TECHNICAL BULLETIN

DATE: 12 JUNE 2001
PAGE 1 OF 6

CYCLIC TRIM ACTUATOR HOUSING REPLACEMENT OR MODIFICATION

Figure 1. Machining of Actuator Housing

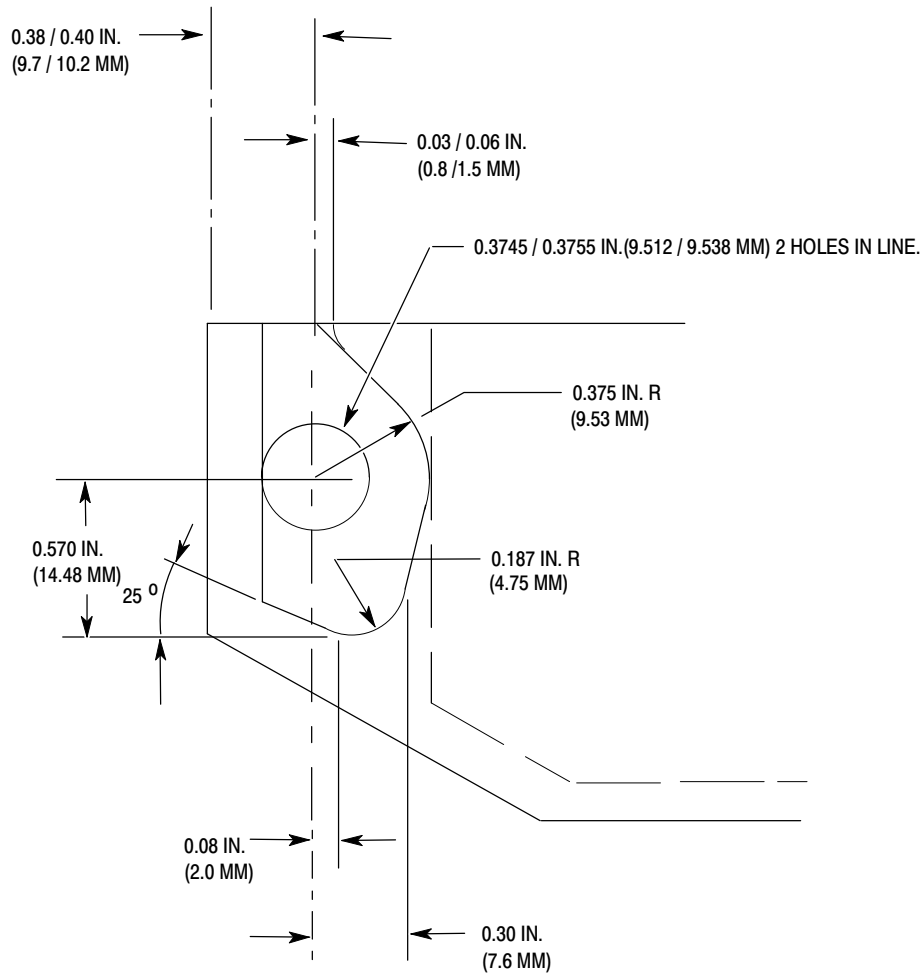
- (1). Remove both bushings from housing.
- (2). Machine housing as shown for longitudinal actuator. Machine opposite side of housing for lateral actuator.

NOTE: LONGITUDINAL ACTUATOR
SHOWN, LATERAL ACTUATOR
IS OPPOSITE.

Figure 2. Rework of Actuator Housing

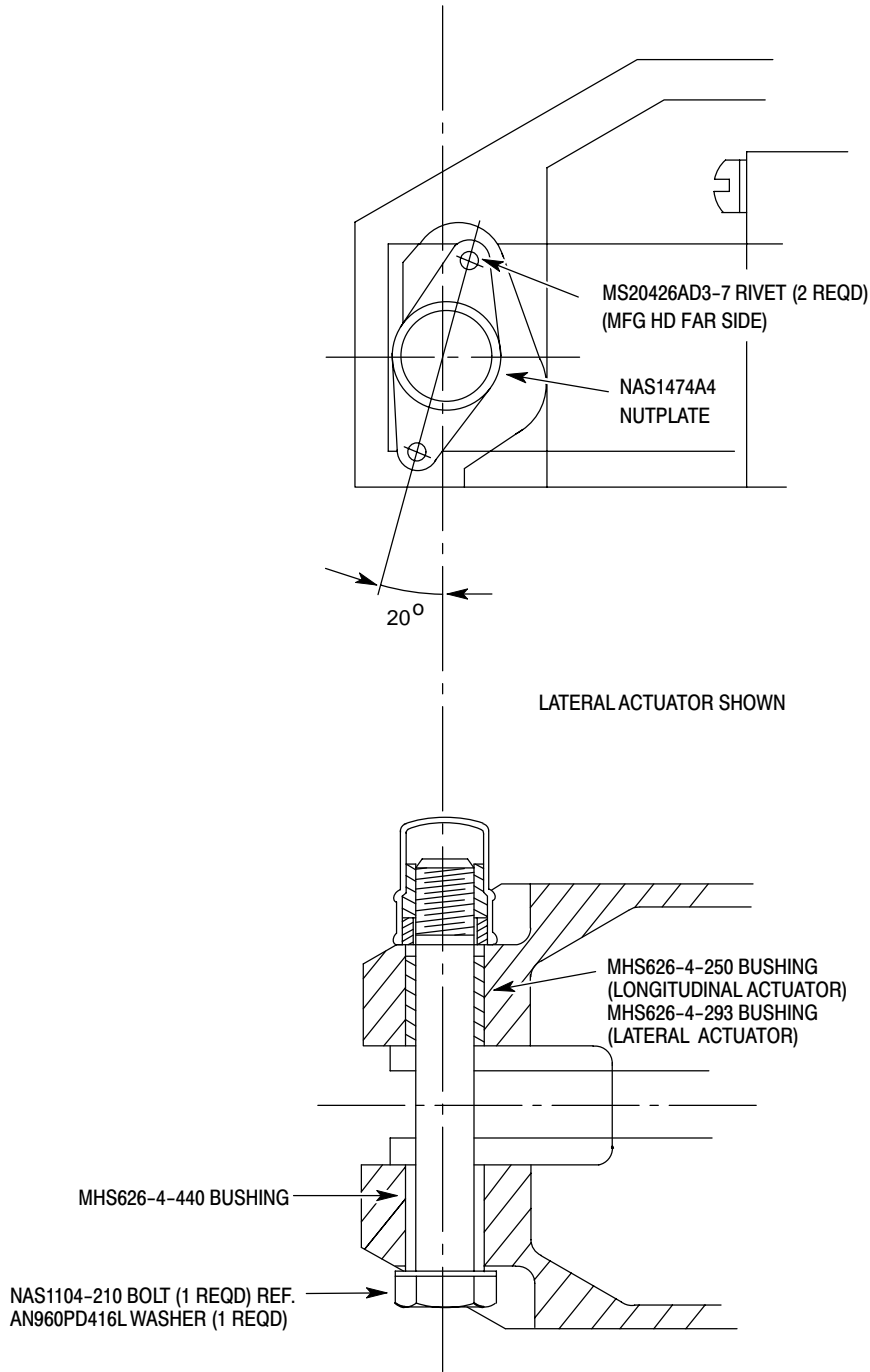
- (3). Locate and drill two 0.0980 inch (2.489 mm) nutplate installation holes in housing using #40 drill. Back countersink holes at inside surface of lug using #40 piloted back counter sink.
- (4). Finish machined surfaces to 125 RMS.
- (5). Perform a dye penetrant inspection in accordance with MIL-I-25135 or fluorescent inspection in accordance with ASTM E1417 for cracks in reworked surfaces.
- (6). Chemically treat exposed magnesium (CSP-A-3, Section 5, Magnesium).
- (7). Apply epoxy primer to reworked surface per manufacturer's instructions.

NOTE: If original bushing is serviceable, it may be cut down to a length of 0.250 inch (6.35 mm) for longitudinal actuator and 0.293 inch (7.44 mm) for lateral actuator and reinstalled.

- (8). Install reworked or new MHS626-4-250 (longitudinal) or MHS626-4-293 (lateral) bushing in housing on nutplate side.
- (9). Install new MHS626-4-440 bushing in housing on bolt head side.
- (10). Install nutplate on housing with two rivets.
